REPORT OF ALTERATIONS TO DESIGNATED RESOURCE

Site Number/Address: 600 Mathews St.

Laurel School National Register Historic District

ISSUED: May 20, 2020

A3.1

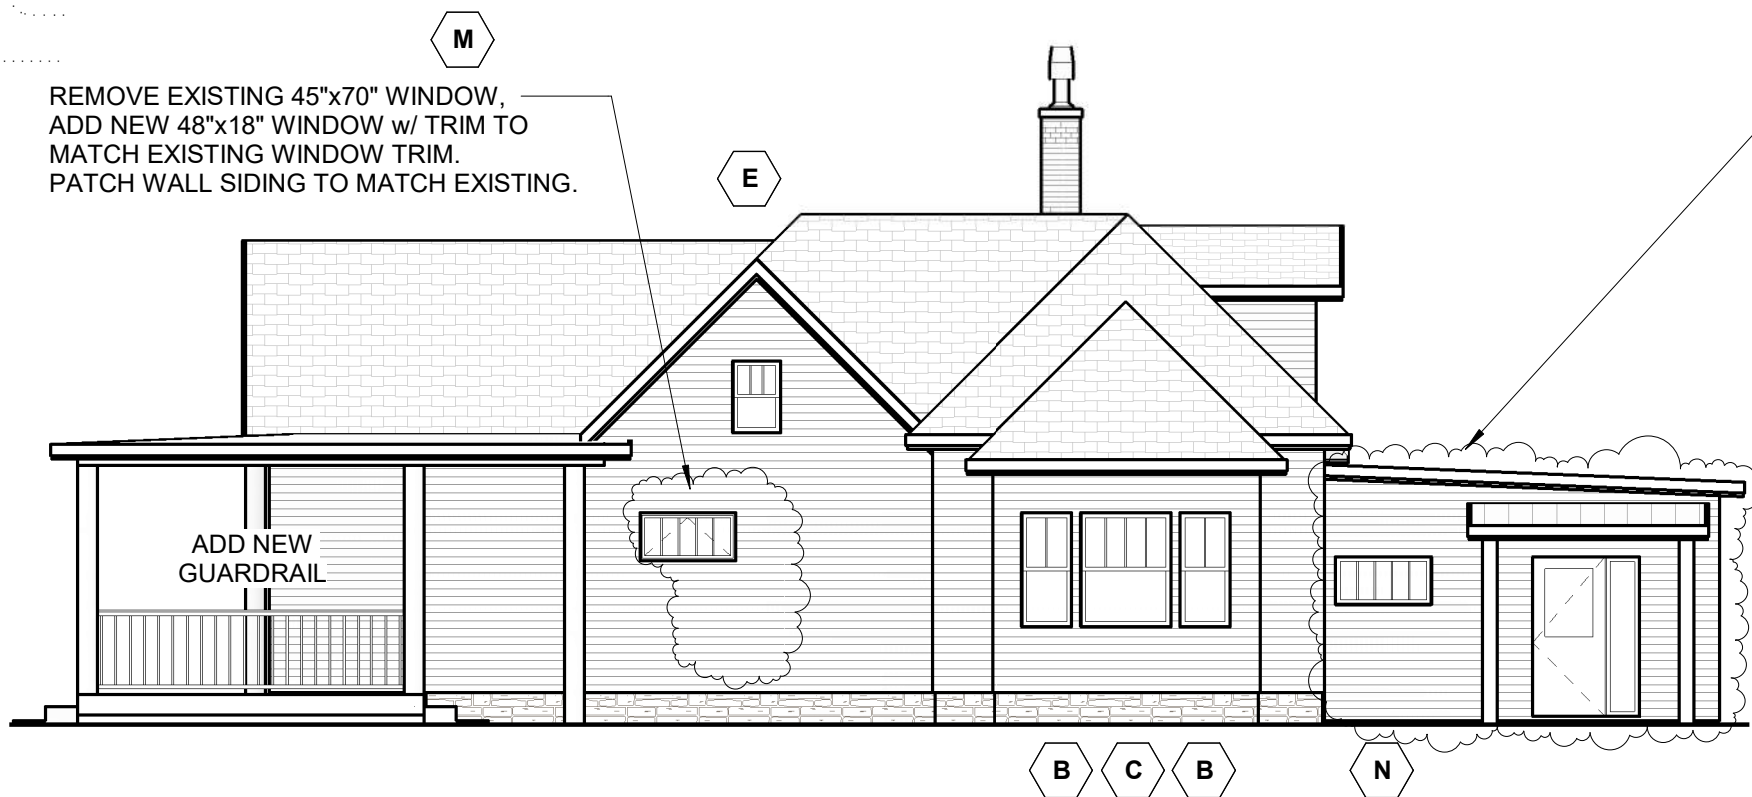
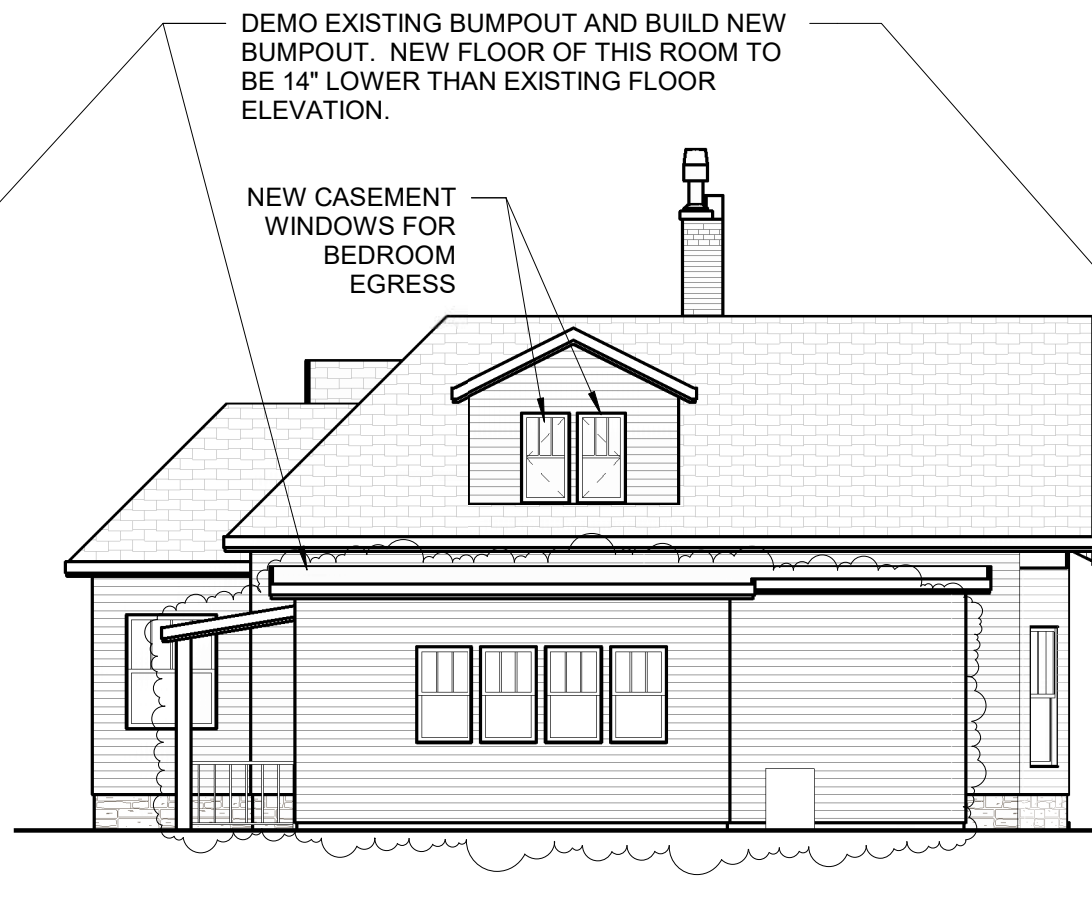
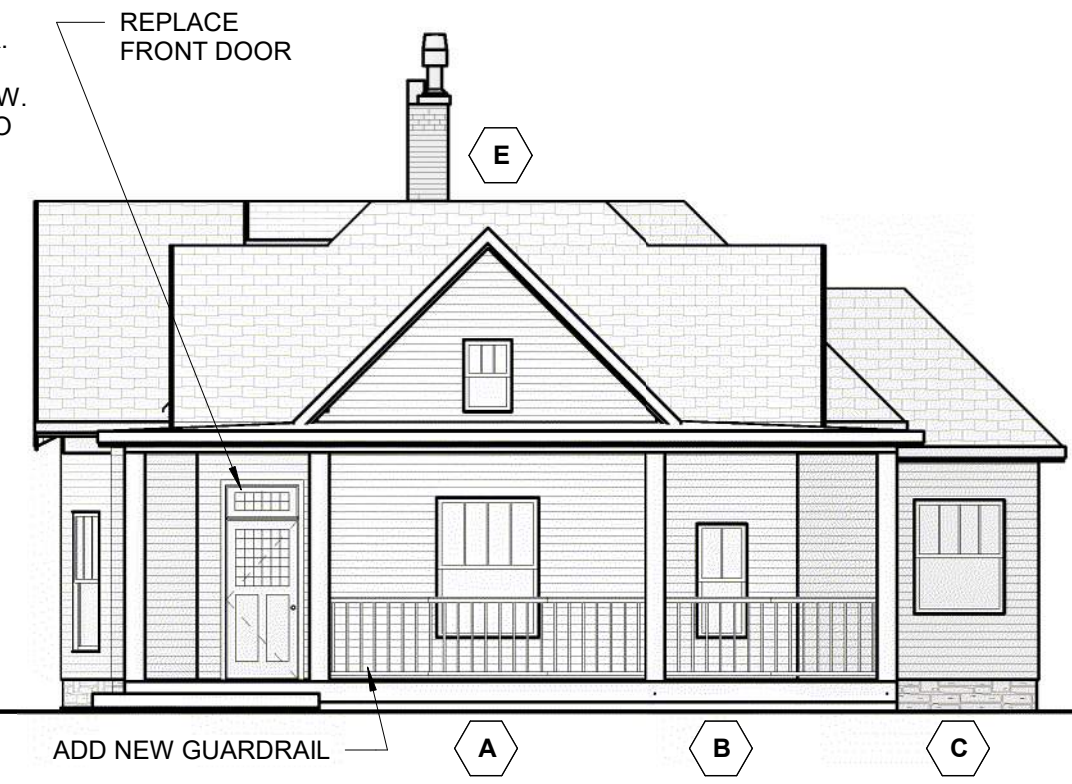
- We had discussed the north doorway since having two entries so close is unusual – you'll just want to explain the justification of why that is being removed.

- On the windows, beyond concerns about operability and energy performance, you'll want to be prepared to speak to condition. Furthermore, since you're proposing a configuration away from the historic (from 1/1 sash to a 3/1 or 4/1 sash), you'll want to explain any documentation that led you to that decision. Typically, even when replacements are justified, they are supposed to be in-kind (i.e., close to an exact match to existing), or should be based on historic photography of the specific property in question, to avoid creating a false sense of history. The windows you are proposing for replacement are more typically found on later Arts-and-Crafts era homes (1910s-1930s) rather than Victorian era (1880s-1910s) homes like this, so their use in this case seems anachronistic.

There are two entry doors side-by-side on adjacent exterior walls accessing the front porch. One of the doors is on a west wall facing Mathews Street and provides access to the main entry hall. The other door is on a north wall facing Myrtle Street and provides access to a room that will become the master bedroom after the renovation is complete. Currently, when a guest steps on the front porch they are greeted with these two doors of matching style which gives the appearance of two "front" doors. Eliminating the north-facing door removes this confusion and keeping the west-facing door complies with Land Use Code 4.8(F)(1)(b) of the NCM Zone District which requires that the primary entrance to a dwelling be located along a front wall and not a side wall.

Generally the condition of the wood window frames and sashes are intact but with moderate and severe weathering and have damage due to nail holes & staples, some broken ropes, rotten wood frames, loose sashes with no weather stripping, lack air tightness, uninsulated single pane glazing, weathered finish, weakened sash joints, a few windows (mostly south-facing) are missing sections of stops, and messy caulking.

A1.3

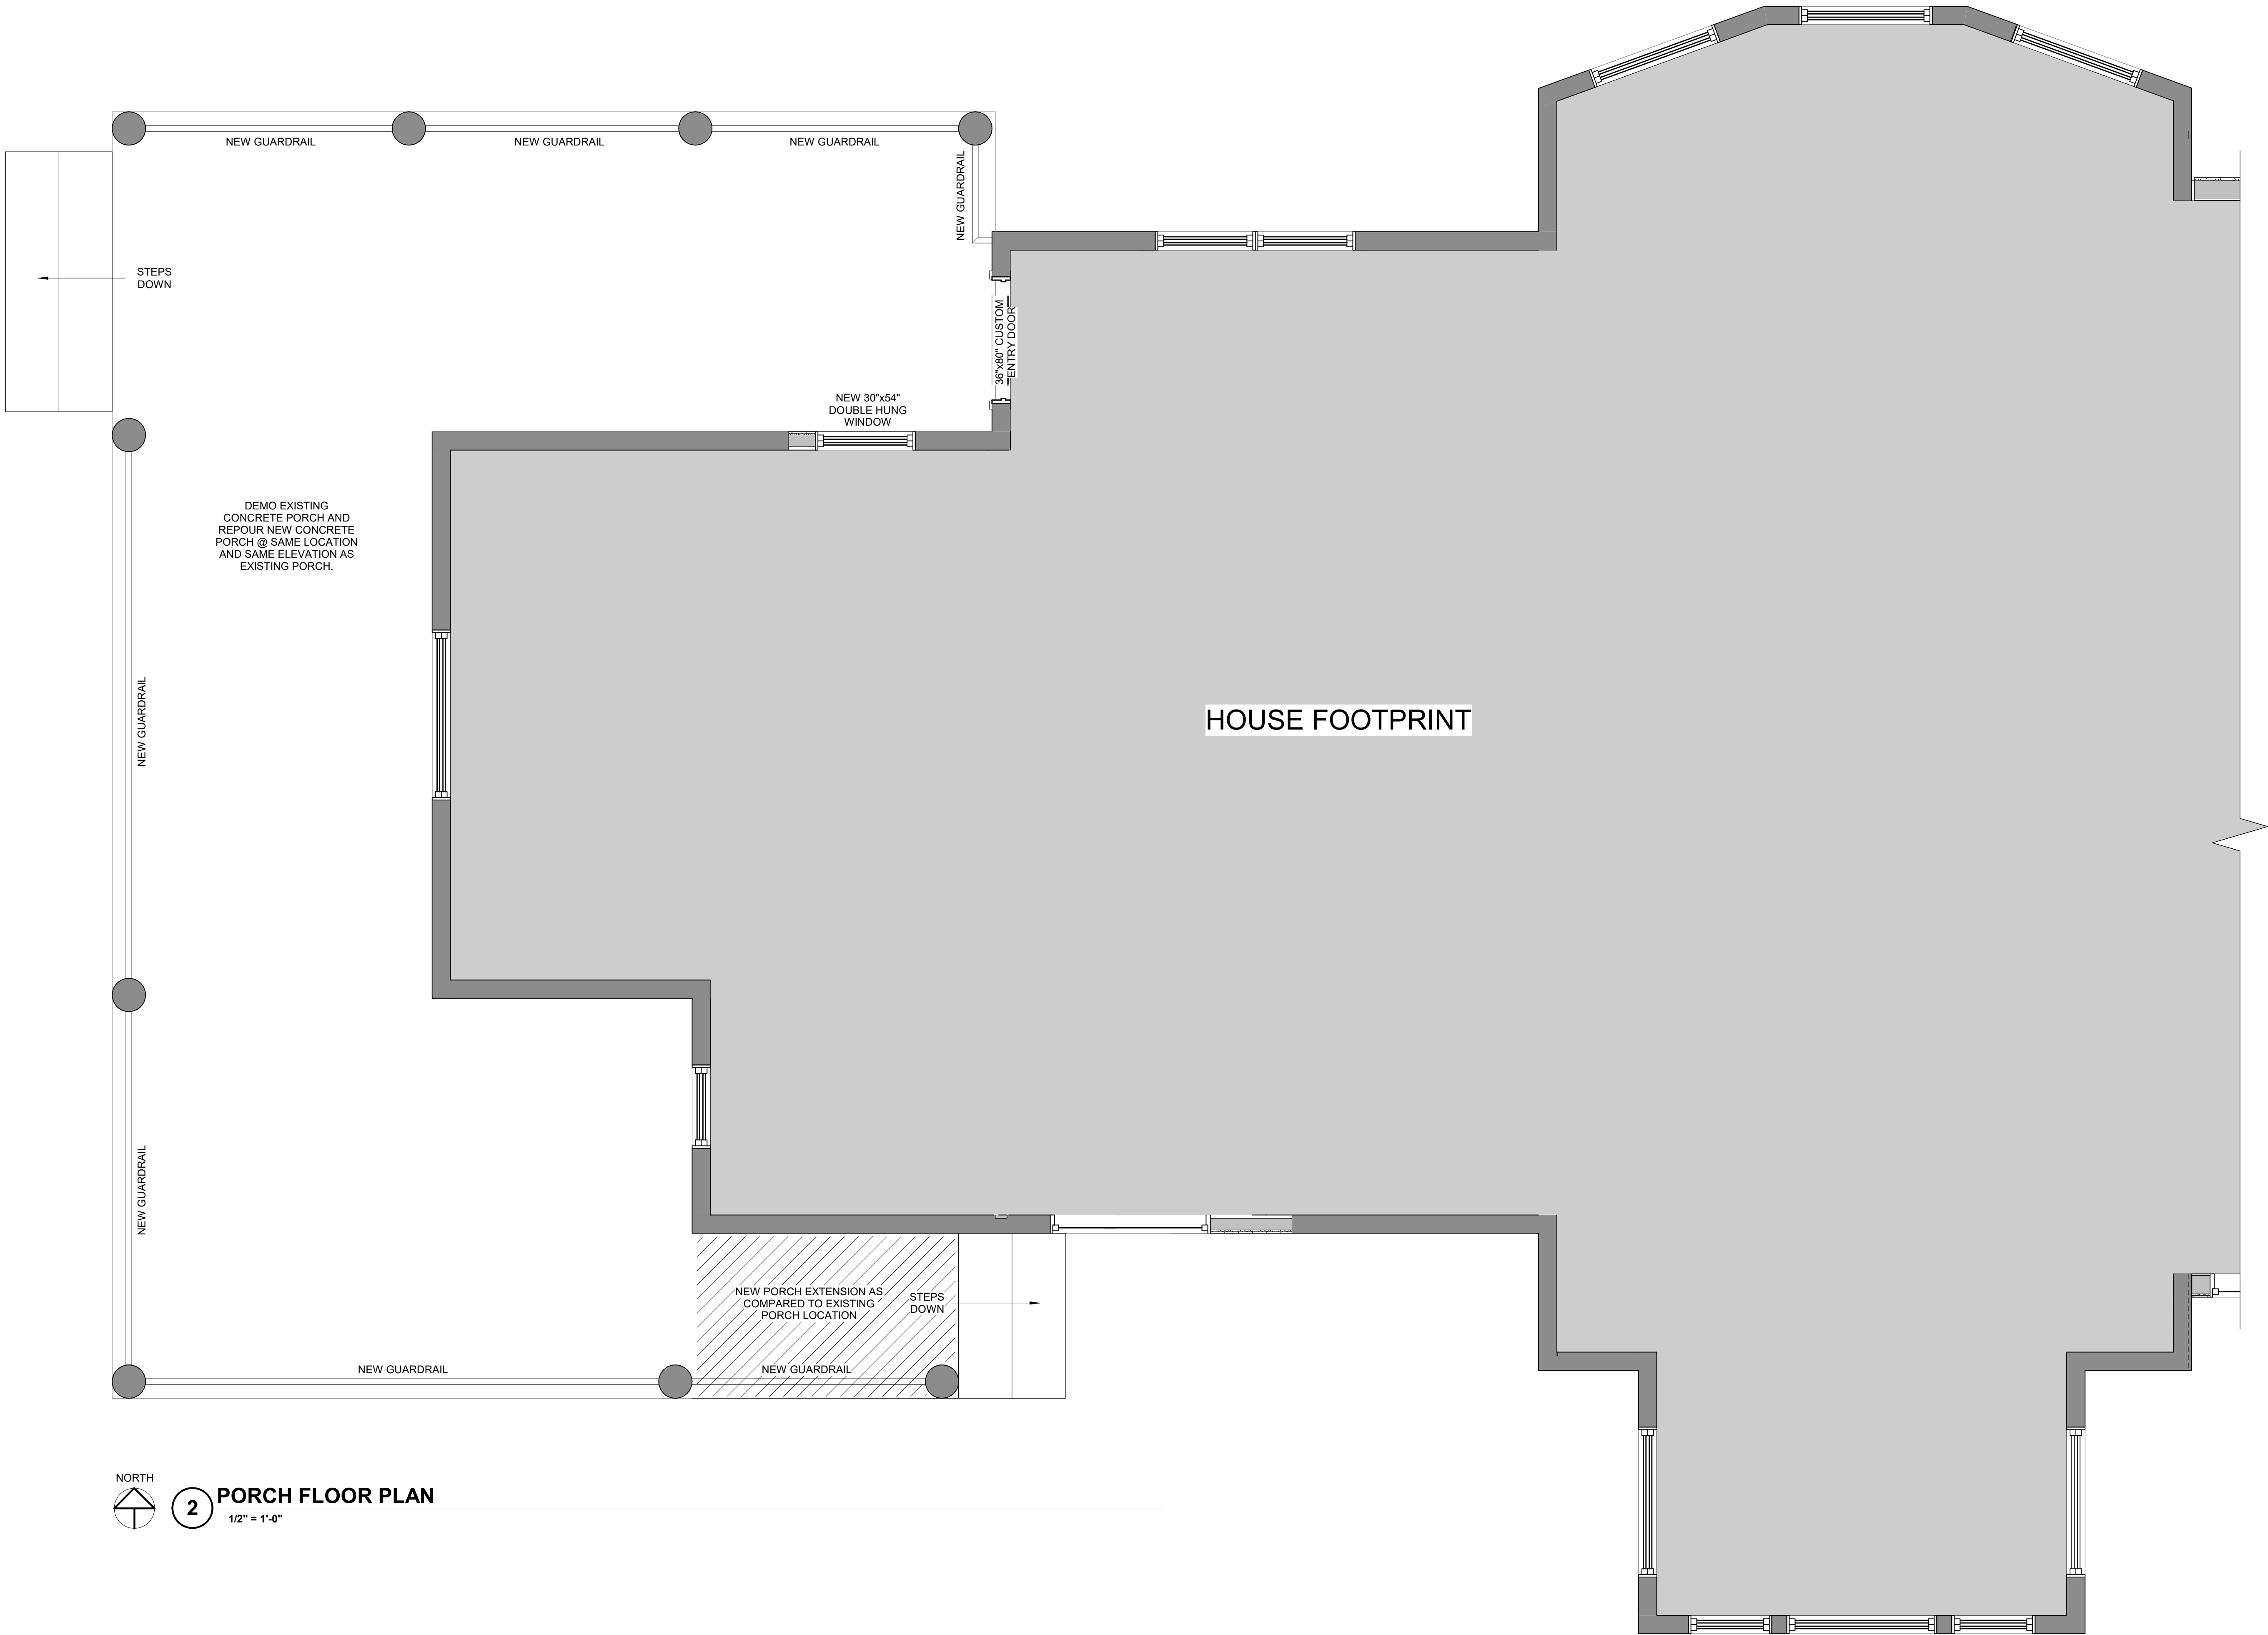
- b. Deck can only come up about 2" - how are they handling the porch columns and bases while raising the deck?**

- b. In what locations is the guard rail being added?**

The homeowners' concerns regarding the porch have been regarding major cracking in the concrete porch and its potential for being or becoming a trip hazard. (Please see attached picture.) Our previous solution to this problem was to leave the concrete slab alone and over-frame with a synthetic decking system. However, after further review we have decided it would be best to remove the existing porch and repour a new concrete porch in the same location and at the same elevation as the existing porch. There is one deviation we'd like to make: we propose to extend a small section of porch at the south end to receive an existing porch column that currently is sitting on an isolated and inconsistent concrete pier. We could also correctly plumb this column in the process to it matches in line with the existing columns. Also there are currently a few existing column bases that are damaged or have been altered or are missing. We will be repair or replacing these bases as necessary. And there is one column that appears to have been replaced with an unmatched column with no taper, no base nor capital. This column will be replaced with a column to match the other existing columns. Please see attached pictures.

The guardrail will be added per plan provided on attached sheet A1.3. New concrete steps will be added at locations indicated on the plan as well. This plan is a change from the design provided in the original proposal dated 03/20/2020.
